Rezoning Application: PD 24-0031

Zoning Hearing Master Date: March 25, 2024

Development Services Department

AGENCY REVIEW COMMENT SHEET

8.0 PROPOSED SITE PLAN Option 2 (FULL)

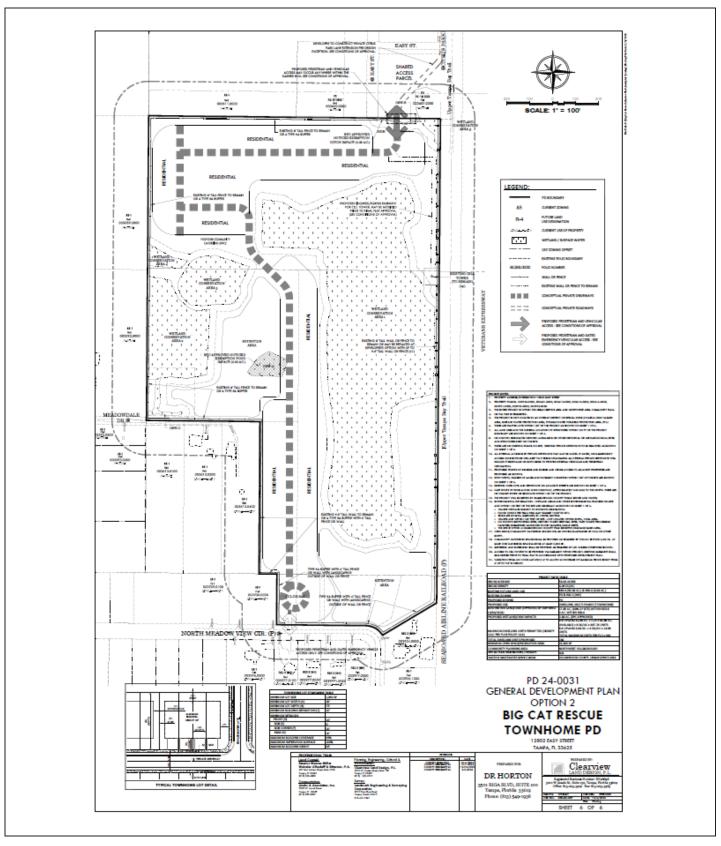
- 4. Sheet 6: remove 100% impervious surface percentage from the Townhome Lot Standards Table.
- 5. Prior to PD Site Plan Certification, the developer shall revise the PD Option 2 site plan to:

- a. Modify Site Note 10 to add the statement "The emergency access connection shall be gated with a Knox Box or similar device acceptable to the Hillsborough County Fire Marshall."

- b. Modify Site Note 11 to delete the statement "...and cross access to adjacent properties...". Staff is unaware of any proposed cross access, only one (1) vehicular and pedestrian connection to the Citrus Park Ln. Ext. and one (1) pedestrian and gated emergency access to Meadowview Cir.

- c. Add the location of required ADA-compliant trail connections and crosswalks as shown below. Label the two connections as follows: "Proposed Crosswalk #1 See Conditions of Approval", "Proposed Trail Connection #1 See Conditions of Approval", "Proposed Crosswalk #2 See Conditions of Approval", and "Proposed Trail Connection #2 See Conditions of Approval". Also, show and label the areas designated Tract A and Tract B within PD 23-0993. Note to be added which states "The locations depicted are general in nature and final locations are subject to design and applicable conditions of approval."

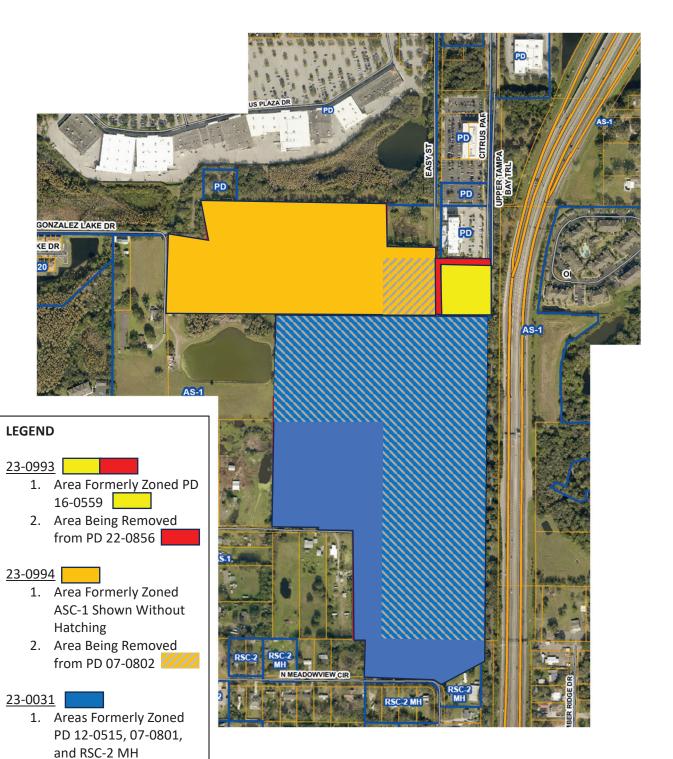
The applicant's Engineer of Record (EOR) submitted a Design Exception request (dated March 15, 2024) to request a deviation from the Hillsborough County Transportation Technical Manual (TTM) requirements for the westbound to southbound left turn lane and eastbound to southbound right turn lane at the intersection of Citrus Park Ln. and Gunn Hwy. Based on factors presented in the Design Exception request, the County Engineer found the request approvable with conditions (on March 18, 2024). The deviations from required turn lane lengths are as follows:

- The applicant is proposing to reduce (by 113 feet) the required westbound to southbound left turn lane length, from a required length of 485 feet to a reduced length of 372 feet; and,
- The applicant is proposing to reduce (by 140 feet) the required eastbound to southbound right turn lane length, from a required length of 385 feet to a reduced length of 245 feet.

These Design Exceptions would require the developer to extend to the westbound to southbound turn lane to the length indicated above, while the existing eastbound to southbound right turn lane would be left in its existing condition.

The County Engineer found the request approvable with certain conditions, specifically that this Design Exception is conditioned on the owner/developer of PD 22-0856 include (as a part of the zoning modification its required to perform to move land area from that PD into PD 23-0993) a trip cap condition which restricts additional development within that project to a combined total of no more than 2,678 average daily trips, 221 a.m. peak hour trips, and 261 p.m. peak hour trips.

TYPICAL SECTION CITRUS PARK LANE

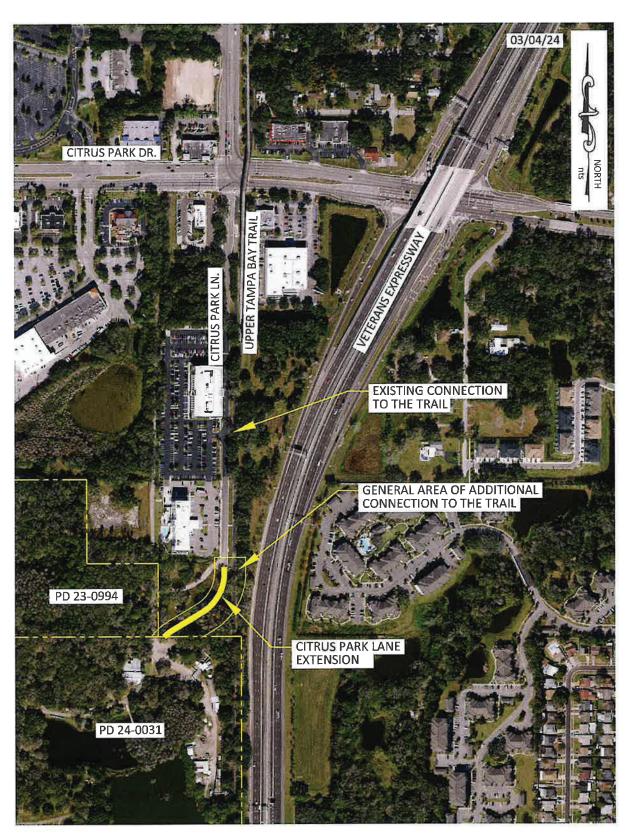
Figure 1 illustrates the proposed typical section for the extension of Citrus Park Lane from the current terminus to PD 24-0031. The deviations and justifications for the variance to TS-4 are as follows:

FIGURE 2
PROPOSED TRAIL CONNECTION

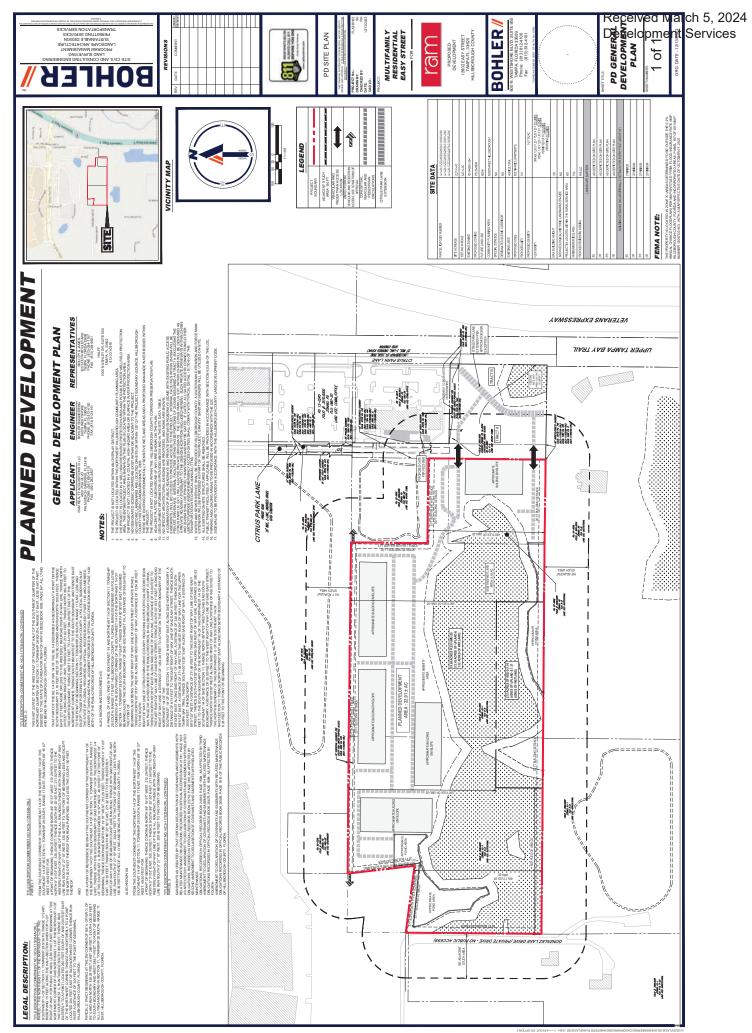
In addition, as mitigated for the substandard road, the developer proposes to provide an additional connection to the Suncoast Trail that is proposed to meet ADA criteria. The final location and design is to be provided at the design stage of the project and approved by the Hillsborough County Conservation and Environmental Lands Management Department. Figure 2 illustrates the general area of the connection.

FIGURE 1 Intersection Improvements

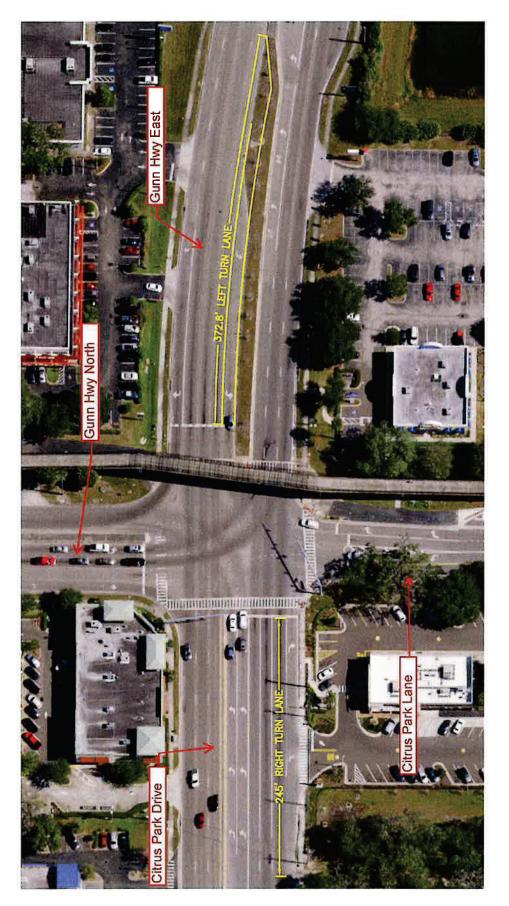
The existing westbound left turn lane is approximately 230 feet. In conjunction with the rezoning of these properties, the developers propose to extend the existing turn lane to approximately 372 feet, as shown in Figure 1.

As shown in Figure 1, the westbound left turn lane can be extended to approximately 372 feet which accommodates the 95th percentile queue for both scenarios. The turn lane can not be extended due to the eastbound left turn lanes for the Veterans Expressway Ramps.

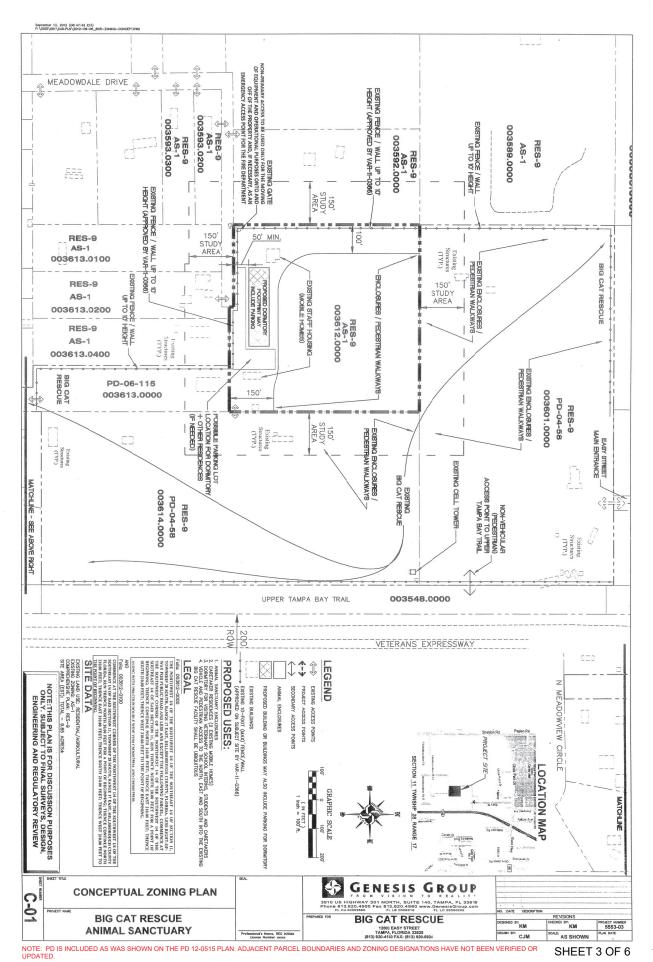
- 2. Sheet 4: Notation to be as shown in PD 04-0058 (as most recently modified by 07-0802)
- 3. Sheet 5 is to be replaced with the certified site plan for PRS 07-0801
